**Creaking Noise from Windshield and Fascia
Area – Plenum Contacting Body Braces –
Repair Procedure**MODEL 1997 MY
XK8 Range
VIN
001001-010766**Issue:**

ILLUSTRATION 1

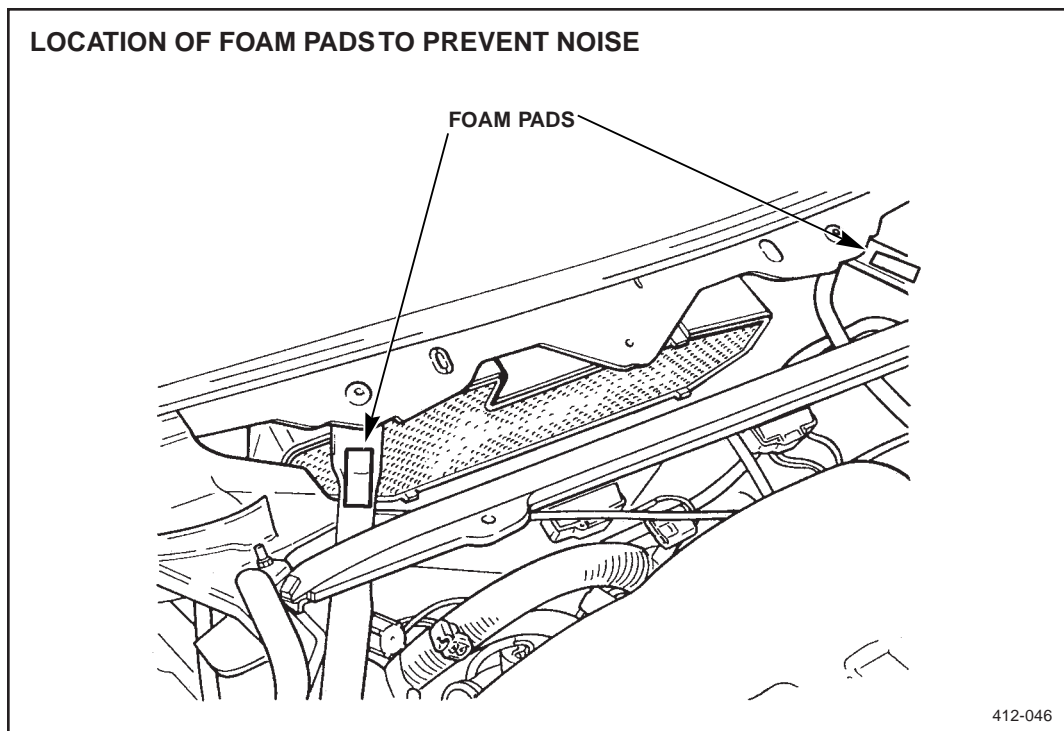
Some 1997 MY XK8 vehicles within the above VIN range may exhibit a creaking noise that appears to come from the fascia or windshield area. The noise may be caused by contact between the plenum cover and the body braces.

In case of a customer complaint of a creaking noise as described above on a 1997 MY XK8 vehicle within the above VIN range, remove the plenum cover. Check the body braces for evidence of contact, such as worn paint. If contact is found, install two closed cell foam pads (HNA-1210BA) on the locations shown in Illustration 1. Reinstall the plenum cover.
